**DEFENSE NUCLEAR FACILITIES  
SAFETY BOARD**

**SUBJECT:** Transuranic Waste Facility Documented Safety Analysis Development Review

**Facility Description.** The Transuranic Waste Facility (TWF) is a new construction Hazard Category 2 nuclear facility designed to be Los Alamos National Laboratory's (LANL) new facility for storage, characterization, and intra-site shipping of newly generated transuranic (TRU) waste. Its mission is to temporarily store and characterize TRU and TRU mixed waste in preparation for shipment to the Waste Isolation Pilot Plant (WIPP). Operations allowed in the facility include filter replacements and container over-packing, but do not include the opening of waste containers. In total, TWF will be able to store and stage up to 1,240 drums or drum equivalents. Figure 1 is included to show the completed facility, which is divided between a general operational area and the Resource Conservation and Recovery Act permitted area where TRU waste operations can be performed. For reference, TWF is located at the intersection of Pajarito and Puye roads in Technical Area 63.

**Figure B-1.** *Empirical vs. Predicted Heat Flux Values (Source: SFPE Handbook, 3<sup>rd</sup> Edition, 2002 [B-3])*

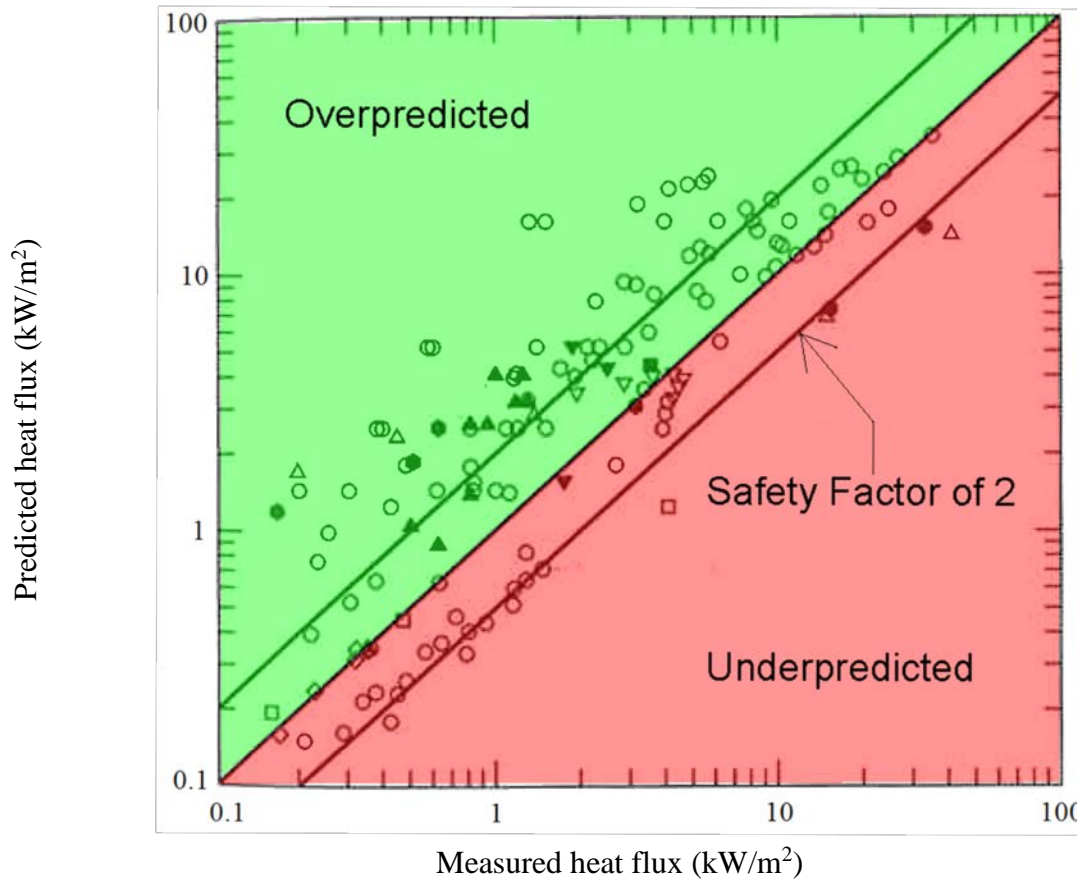
The non-conservatism relates to the use of an appropriate safety factor in the Mudan and Croce method, which is used to determine the fire separation distances in a LANL calculation applied to TWF (hereafter referred to as the "LANL calculation") [B-2]. The Mudan and Croce method, which is described in the Society of Fire Prevention Engineers (SFPE) Handbook [B-3], estimates the radiant heat flux to a target from a source fire. The separation distances are calculated by determining the minimum separation distance between and RFP and MAR that prevents development of radiant heat fluxes associated with waste drum seal failure or lid loss. The SFPE Handbook recommends that a safety factor of two be used with this method:

Figure B-1 shows the predicted and measured heat fluxes from the Mudan and Croce method. Note that without the safety factor, there are a number of data points where the Mudan and Croce method under predicts the radiant heat flux. Using a safety factor of 2 ensures that nearly all of the data points fall in the over predicted region. The LANL calculation [B-2] does not appear to incorporate an explicit safety factor as suggested by the method, and no discussion of this safety factor is provided in the calculation.
